UNITED STATES
DEPARTMENT OF THE INTERIOR
BUREAU OF LAND MANAGEMENTFORM APPROVED
OMB NO. 1004-0135
Expires: July 31, 2010**SUNDRY NOTICES AND REPORTS ON WELLS**
*Do not use this form for proposals to drill or to re-enter an abandoned well. Use form 3160-3 (APD) for such proposals.***SUBMIT IN TRIPLICATE - Other instructions on reverse side.**

WELL NAME: Hickory ALV Fed # 2

**Permanent Abandonment of Federal Wells
Conditions of Approval**

After

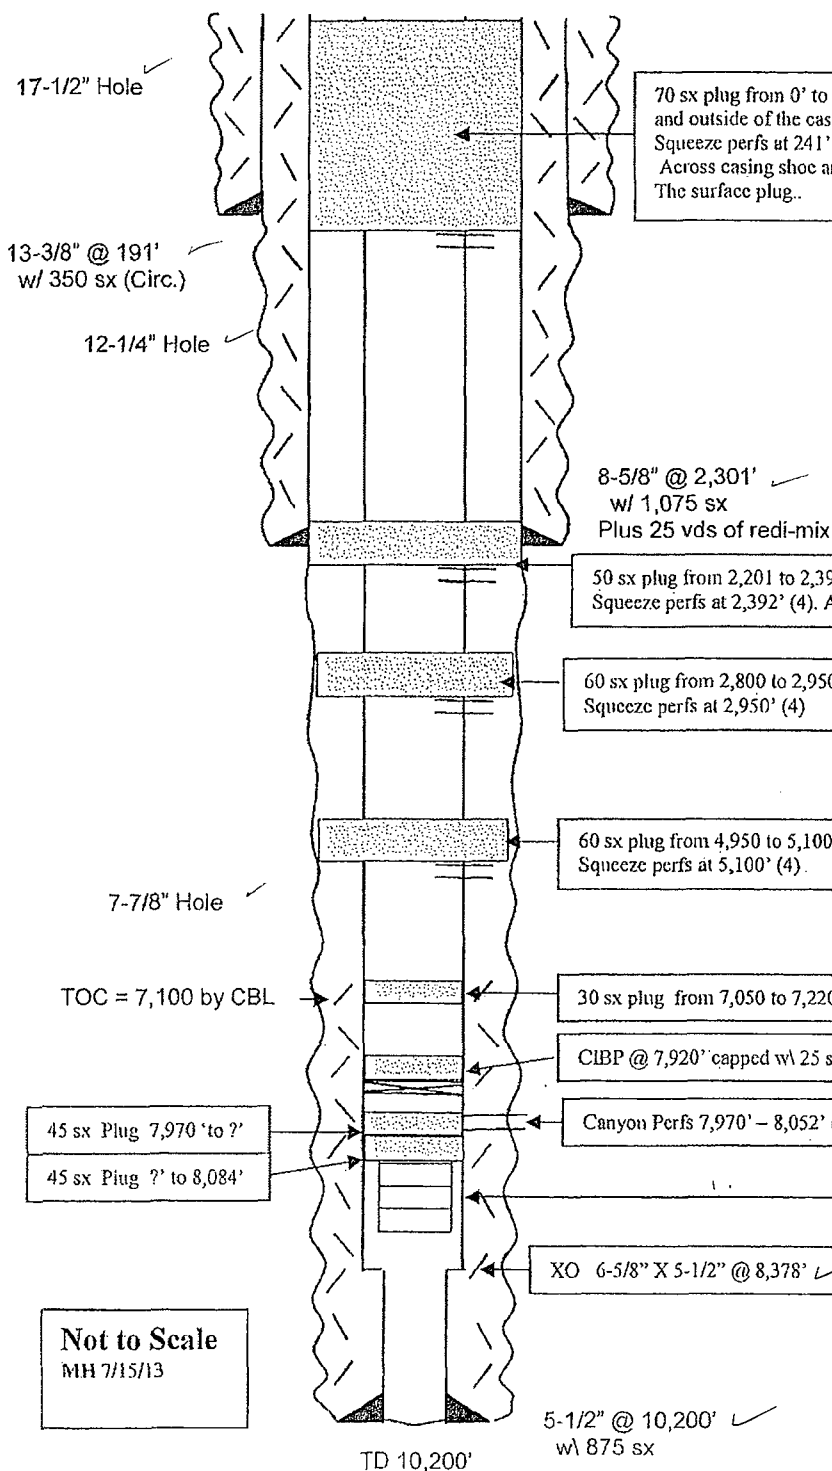
BS 2937

60 sx plug from 2,800 to 2,950', inside and outside of the casing. Squeeze perfs at 2,950' (4)

5. MI RU WL to perforate 4 squeeze holes at ²⁹⁸⁷~~2,956~~ ft. RIH with tubing and packer set the packer at +/- 2,300 ft and break circulation up the 6-5/8 inch X 8-5/8 inch annulus. Pump 60 sx of class C cement and displace it down to 2,800 ft. Release the packer and POOH. WOC and tag if necessary reset the plug.
